**CALIFORNIA COASTAL COMMISSION**

Consistency Determination Number: CD-021-03  
Filed: 3/18/2003  
60th day: 5/17/2003  
75th day extended to: 11/15/2003  
Staff: D. Carl  
Staff report prepared: 10/23/2003  
Hearing date: 11/7/2003  
Hearing item number: F6a

**FEDERAL CONSISTENCY DETERMINATION**

**Project description**.....Construction of full-bluff (extending from the beach/Monterey Bay to East Cliff Drive above) 1,100 linear foot sculpted concrete seawall, construction of one new and one replacement public access stairway, demolition of an abandoned restroom, removal of concrete rubble previously placed on the beach, and relocation of rip-rap boulders.

## Map Legend for Figures 2-5a-c

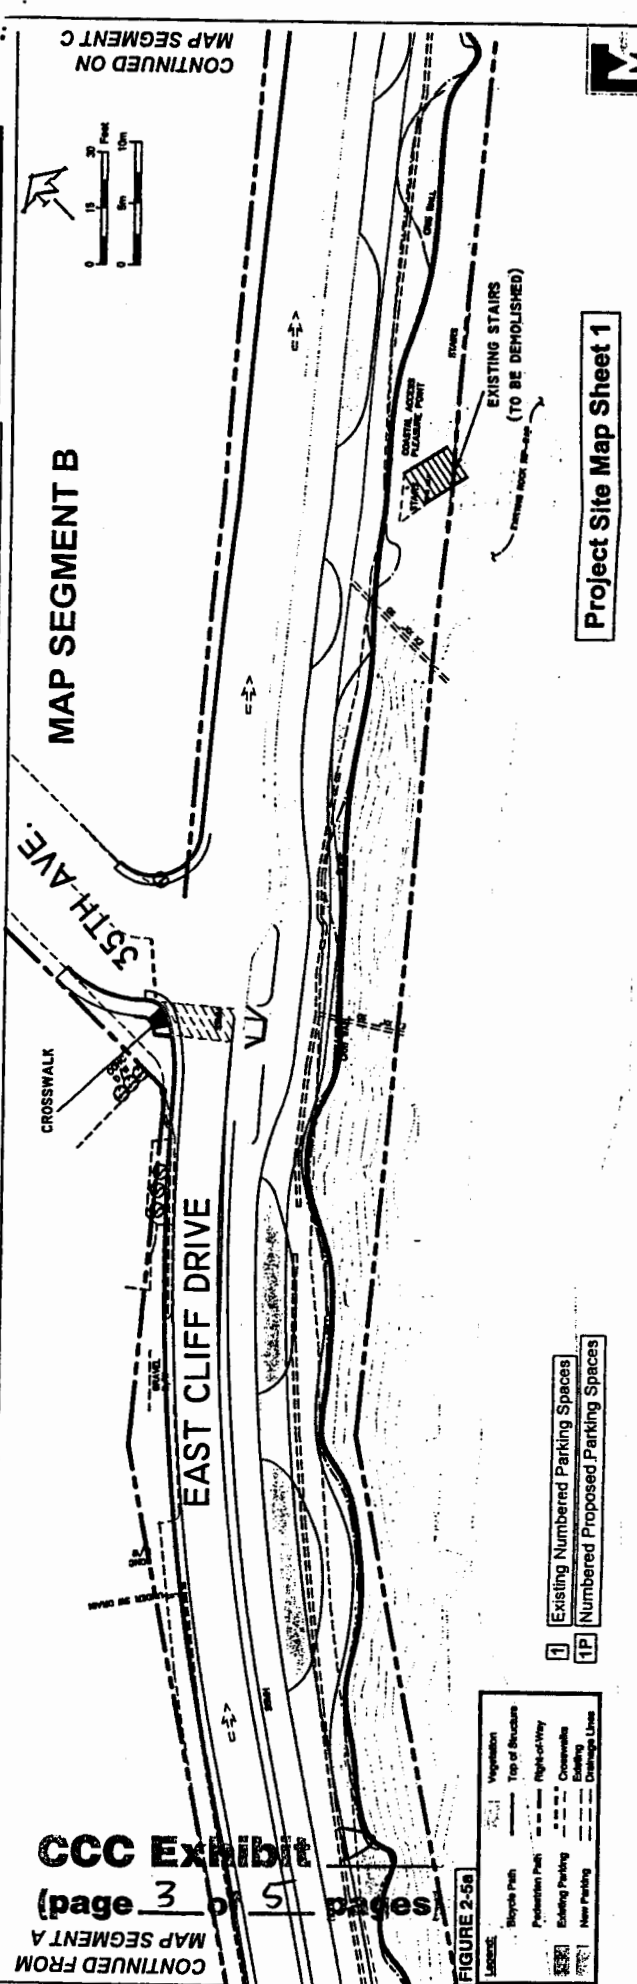
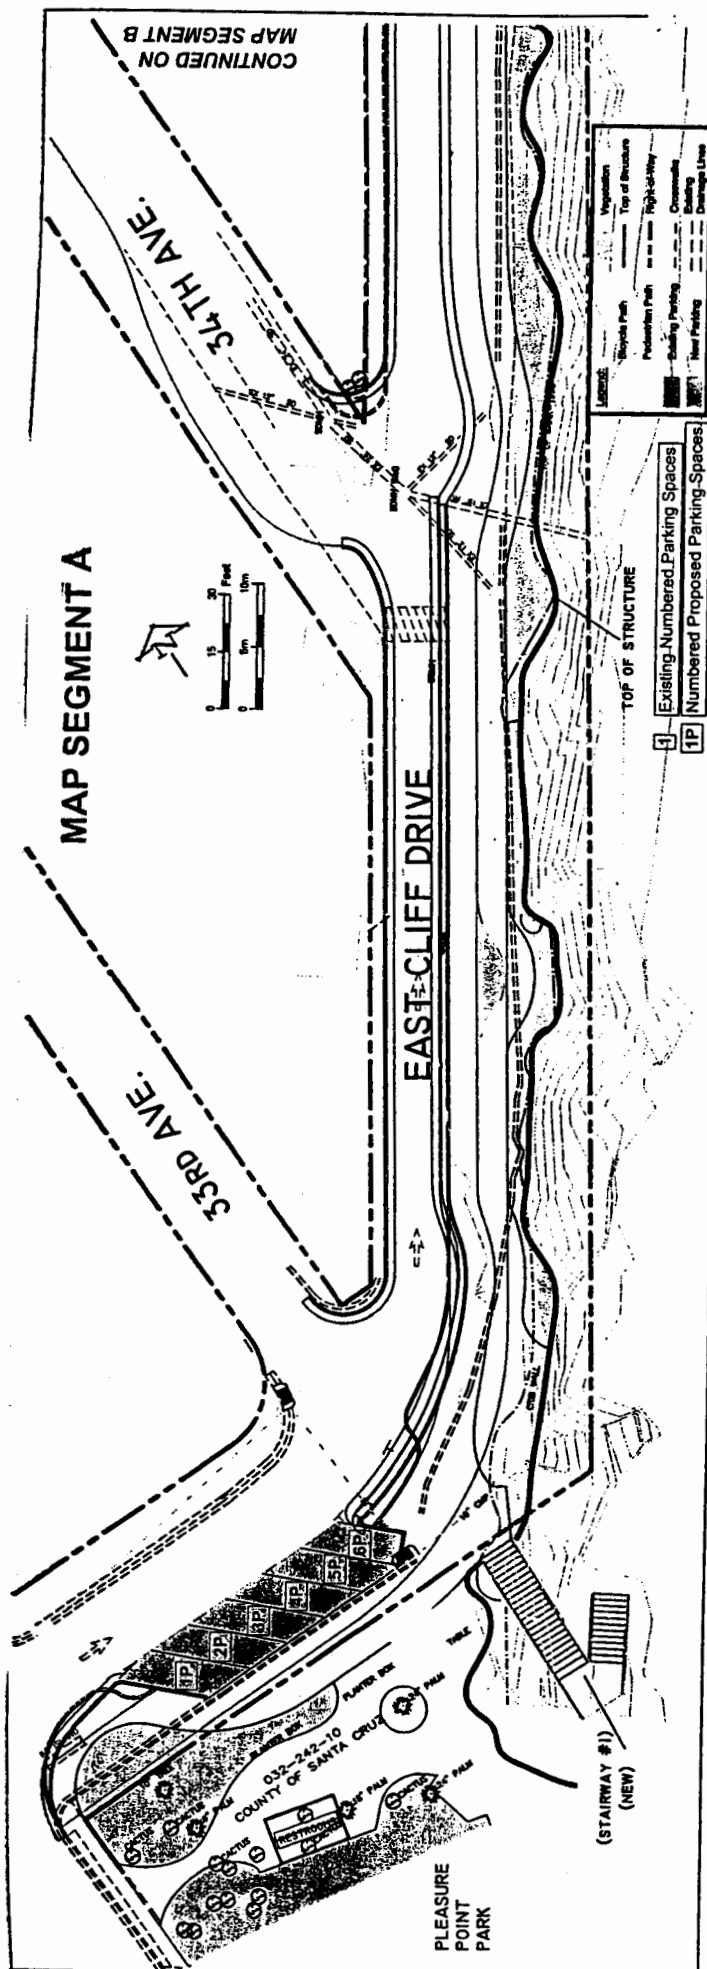
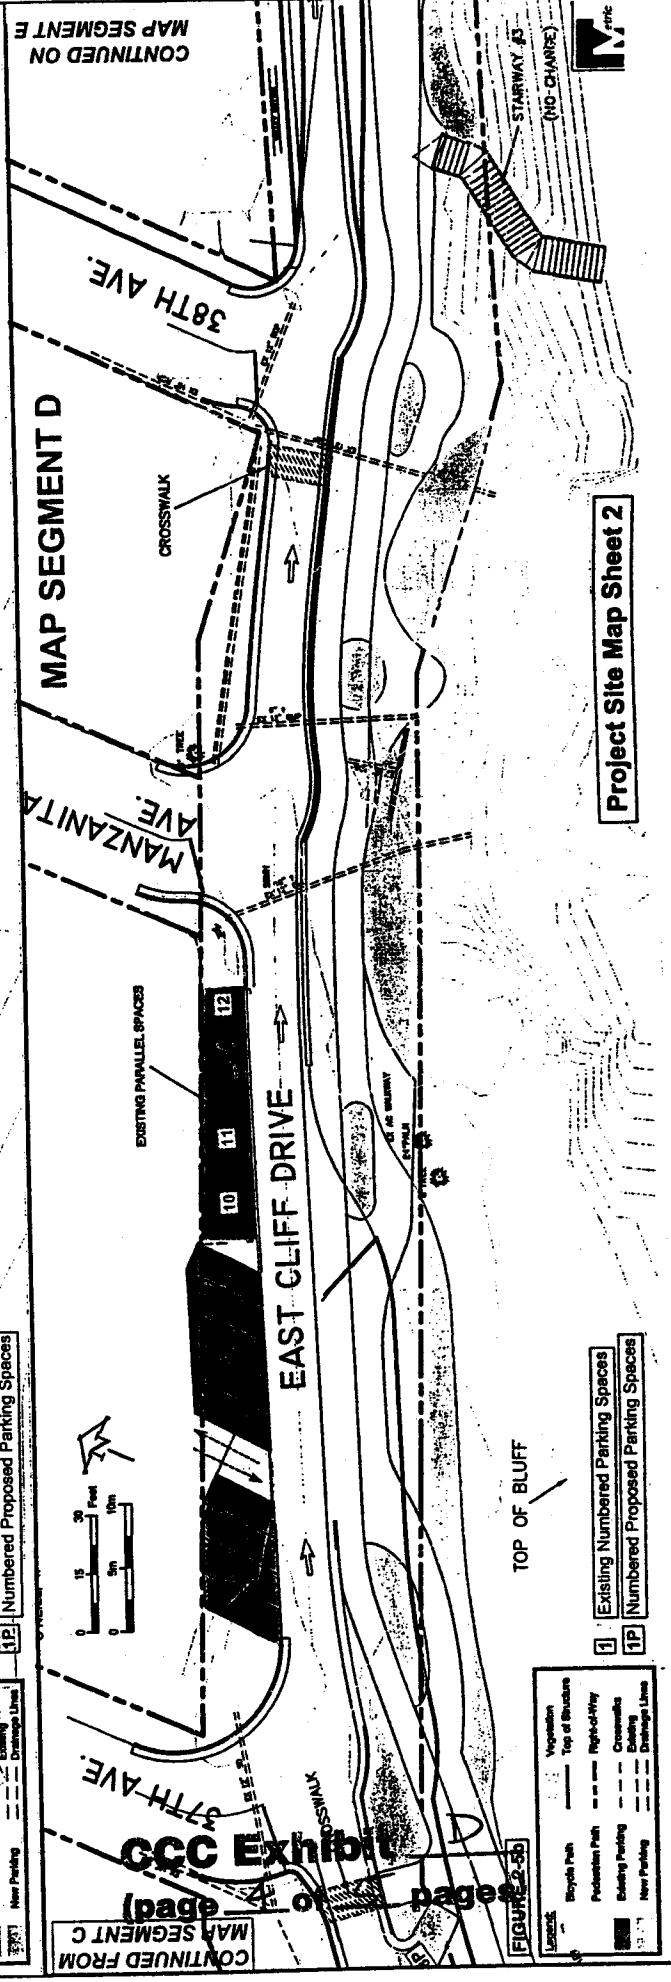
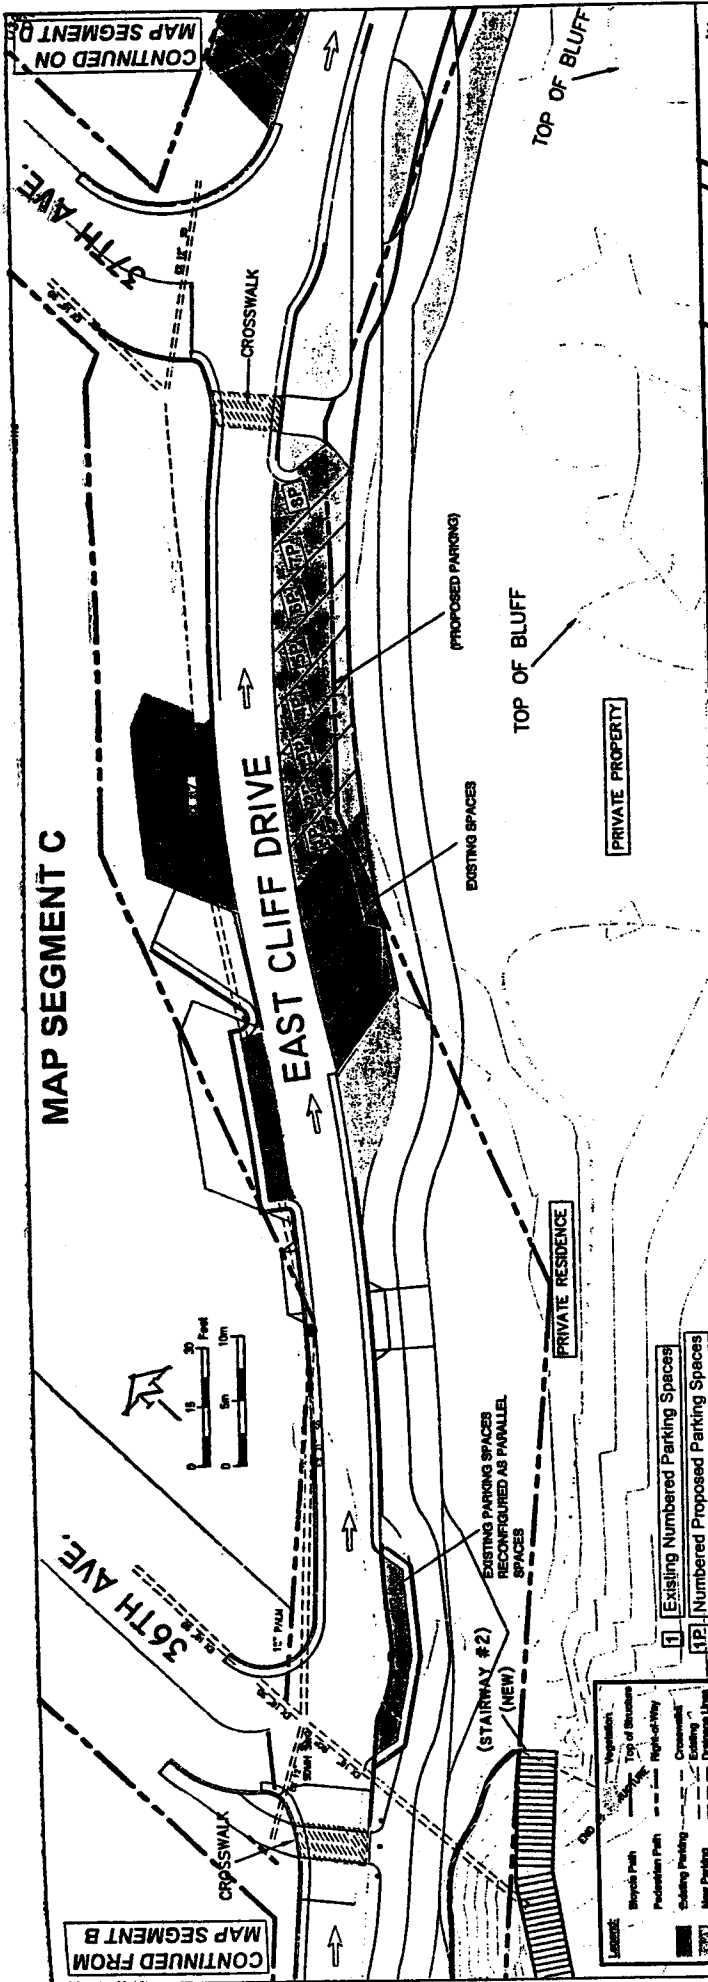
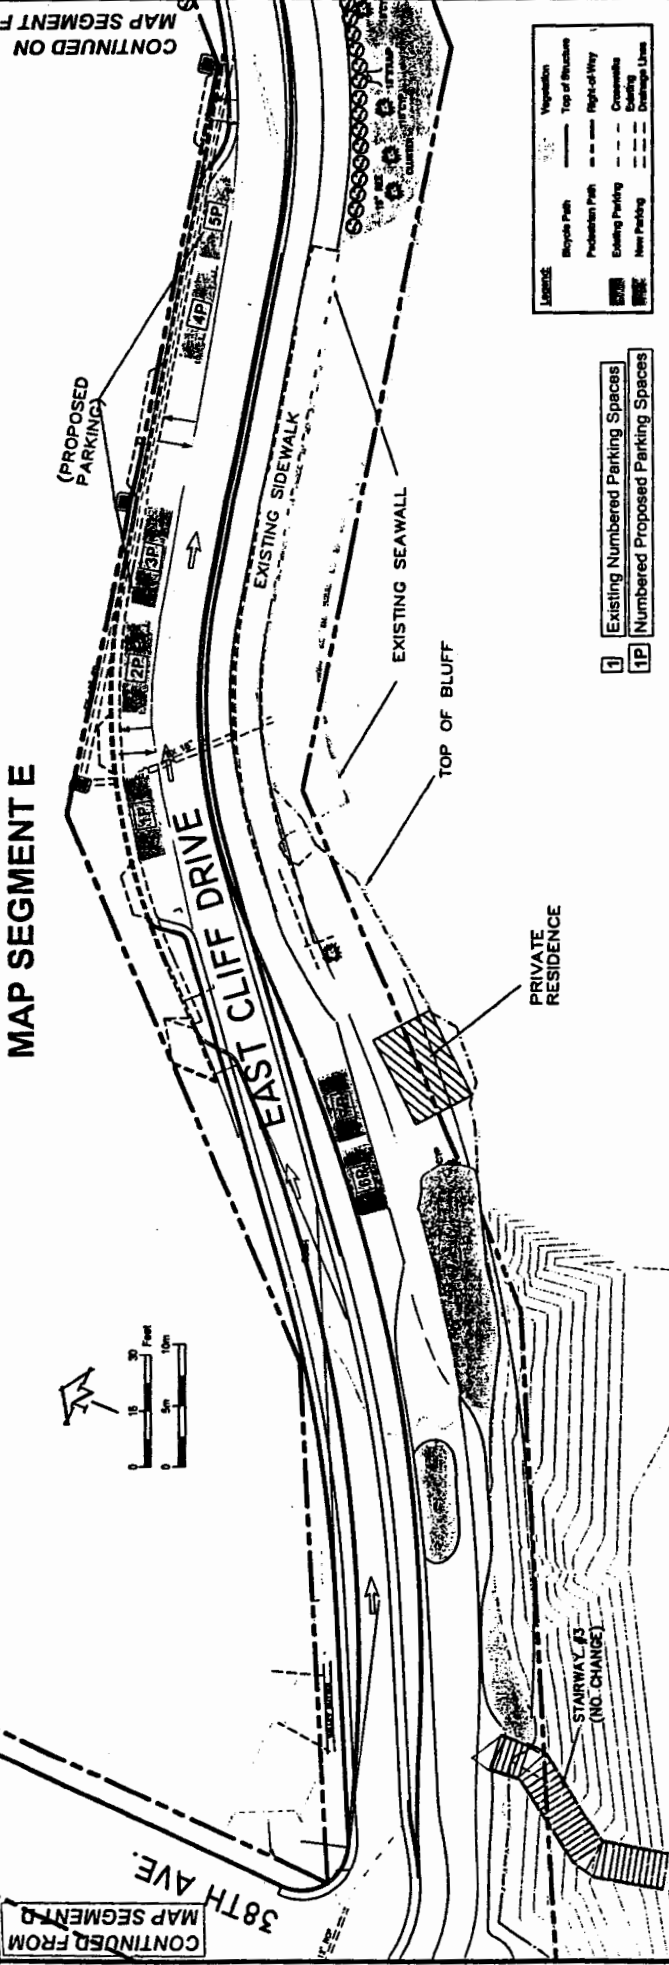
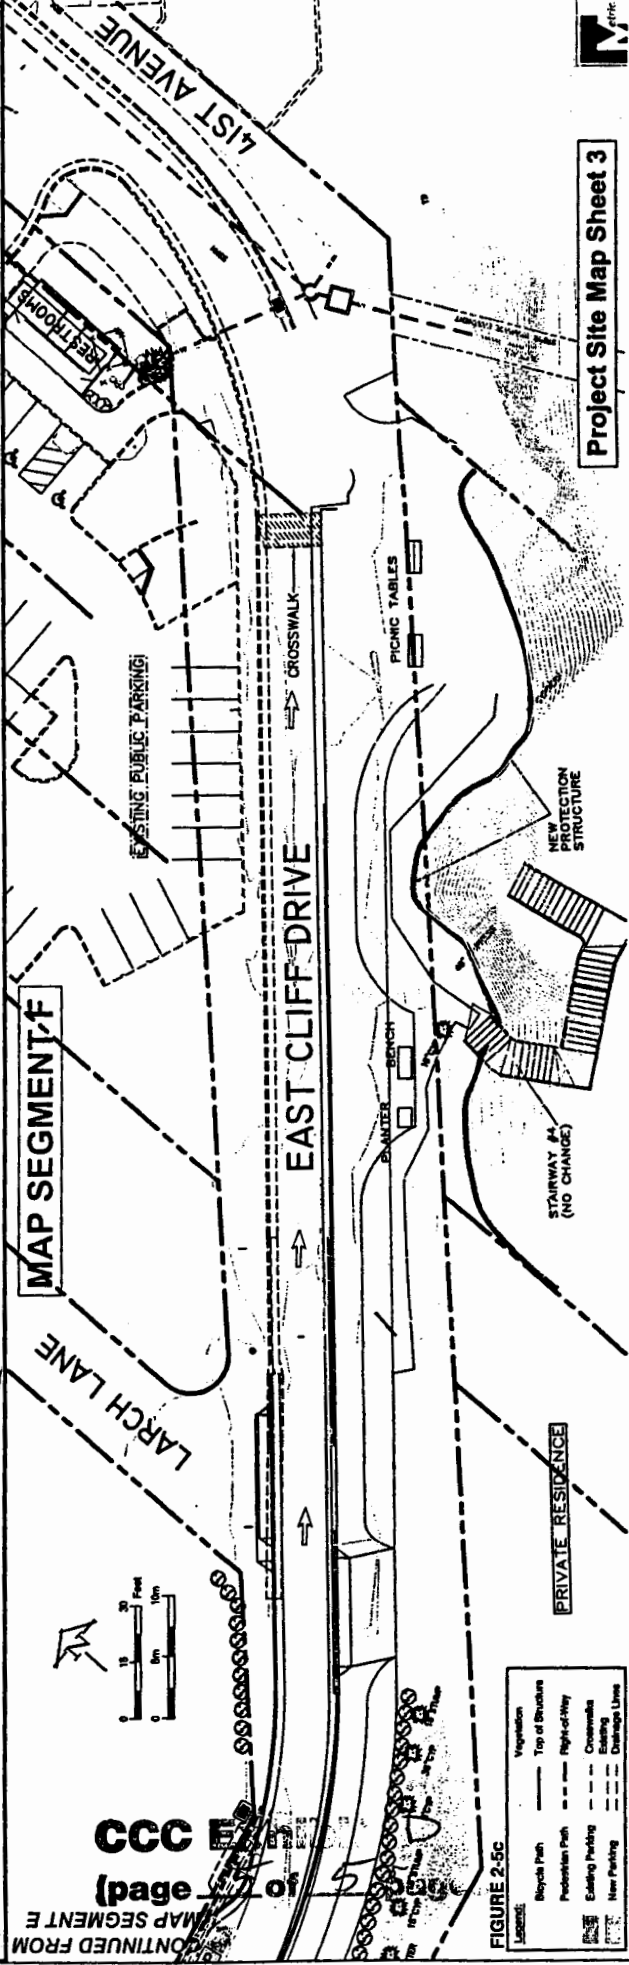
- (34) Figures 2-5a, b, and c lack a scale from which to measure. Please add a scale in feet (metric alone is insufficient).
- (35) The DEIS/DEIR dismisses under grounding utility lines due to expense, but it does not provide any cost figures. Please provide cost estimates for under grounding overhead utility lines along East Cliff Drive from 32<sup>nd</sup> through 41<sup>st</sup> Avenues.
